Contract #: 04-0120F4  
 Cty: SF/ALA Rte: 80 PM: 13.2/13.9  
 File #: 69.25B

## QUALITY ASSURANCE -- NON-CONFORMANCE REPORT

**Report No:** NCR-000540

**Reference Description:** Fillet Weld Excavation with Final QC Acceptance, Crossbeam CB17

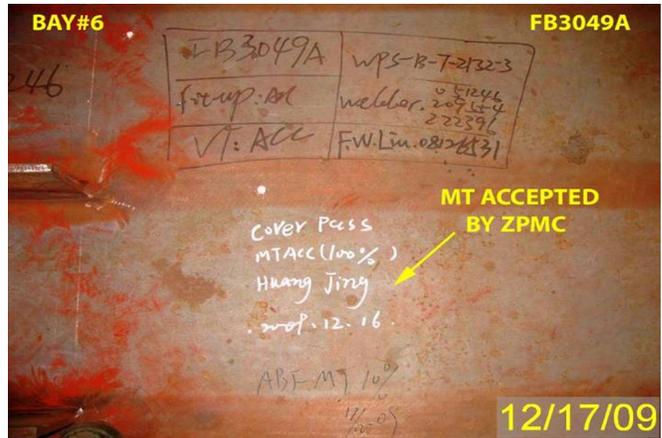
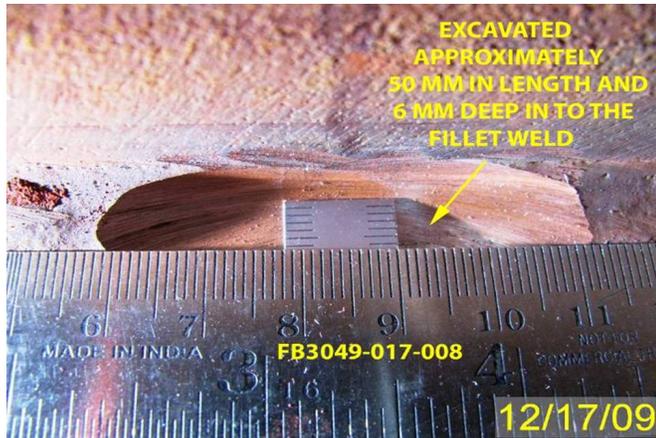
During a random in-process visual verification prior to performing Magnetic Particle Testing (MT) on a Floor Beam (FB) for Crossbeam CB17 located at Bay # 6, the Caltrans Quality Assurance (QA) Inspector observed a fillet weld that had been excavated approximately 50 mm in length and 6 mm in depth. The contractor (ZPMC) offered a formal NDT Inspection Notification Sheet, acknowledging the weld was complete and that ZPMC MT technicians had tested and accepted 100% MT on this FB. Additional information identifying the non-conformance is listed below.

- The Floor Beam is identified as FB3049-017-008.
- The fillet weld connects the FB Web Plate (PL3089A) to FB Stiffener (X3090R).
- The fillet weld size is 6 mm in size per the approved contract drawings.
- The NDT Inspection Notification Sheet request number was identified as: 004835

Component: OBG Segment 6AE Side Panel Repair

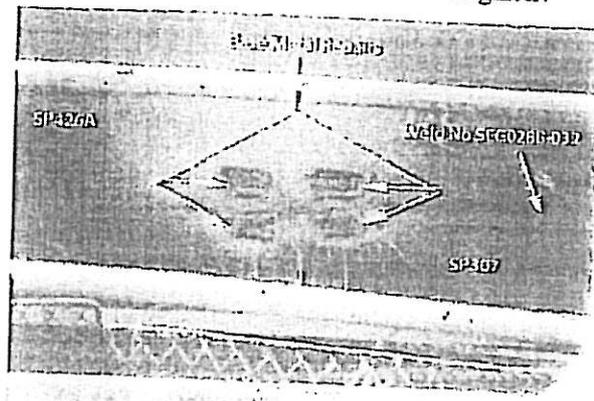
This Quality Assurance (QA) Inspector observed the in-process welding of a base metal repair being performed on side plate SP307 and SP426A adjacent to side plate splice weld No.SEG028B-032 on OBG Segment 6AE. Approximately four areas of 75mm x 75mm of filler material were deposited into four locations, in and around the splice weld to rectify the fit up of the traveler rail bolt attachments by building up the surface thickness to compensate the gap at the faying surface. These additional welds are not in the approved shop drawings or weld map. This is an unacceptable base metal repair and was performed without the approval of the Engineer.

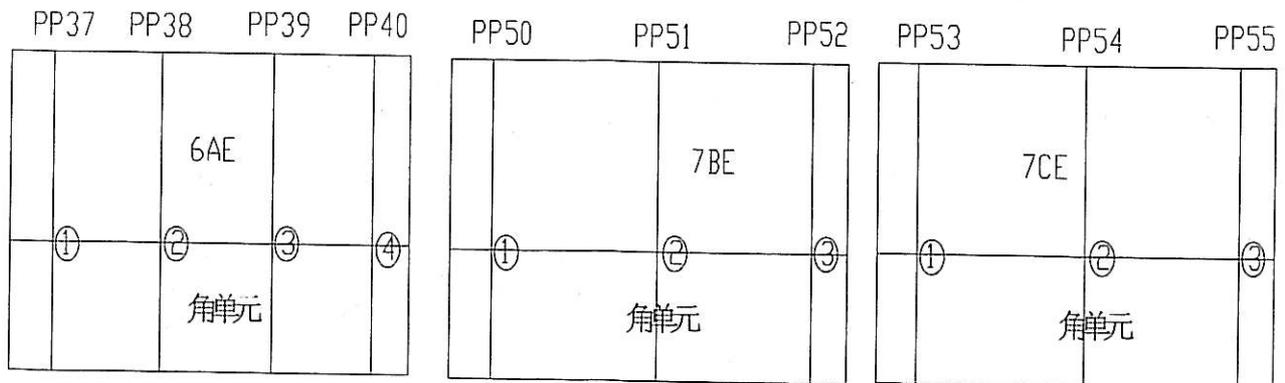
**Description of welding discontinuity:**

According to inspection report 1075# disposition, it shall build up 6AE/7BE/7CE relevant position to ensure flatness, see the following draft.

1. Remove all the defects according to the approved repair WPS by means of grinding.
2. Verify with MT and VT no defects remain in the repair area prior to weld;
3. Preheat and weld according to the relevant WPS.
4. Grind the weld flush with base metal after welding.
5. Perform VT and MT inspection of the repaired area.

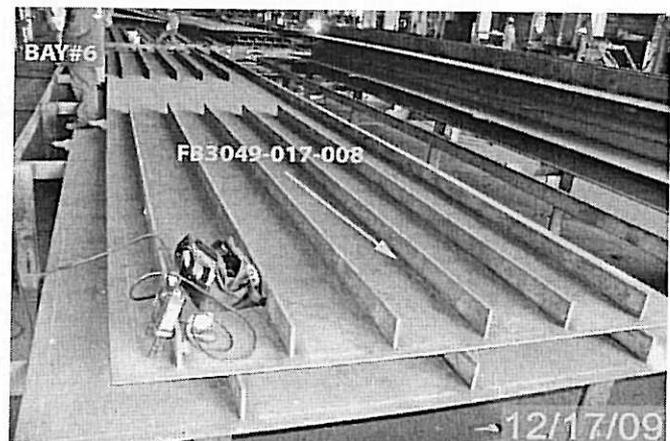
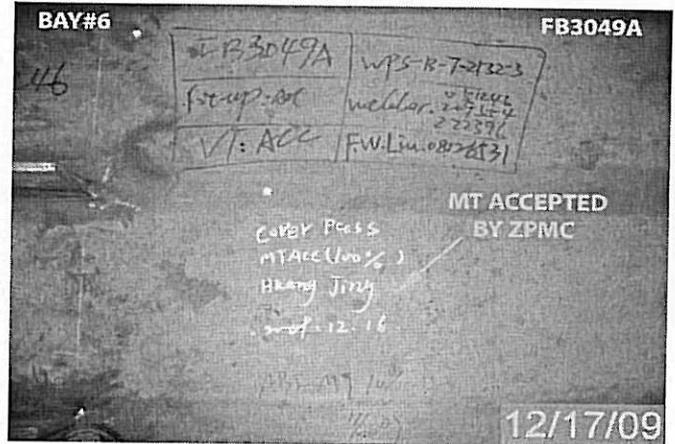
During a random in-process visual verification prior to performing Magnetic Particle Testing (MT) on a Floor Beam (FB) for Crossbeam CB17 located at Bay # 6, the Caltrans Quality Assurance (QA) Inspector observed a fillet weld that had been excavated approximately 50 mm in length and 6 mm in depth. The contractor (ZPMC) offered a formal NDT Inspection Notification Sheet, acknowledging the weld was complete and that ZPMC MT technicians had tested and accepted 100% MT on this FB. Additional information identifying the non-conformance is listed below.

- The Floor Beam is identified as FB3049-017-008.
- The fillet weld connects the FB Web Plate (PL3089A) to FB Stiffener (X3090R).
- The fillet weld size is 6 mm in size per the approved contract drawings.
- The NDT Inspection Notification Sheet request number was identified as: 004835

Repair said excavation and perform NDT required to verify weld quality.

Contractor submitted NDT records verifying weld has been repaired and is in conformance with Contract weld quality requirements. An internal NCR was also issued by the contractor in regards to this matter.
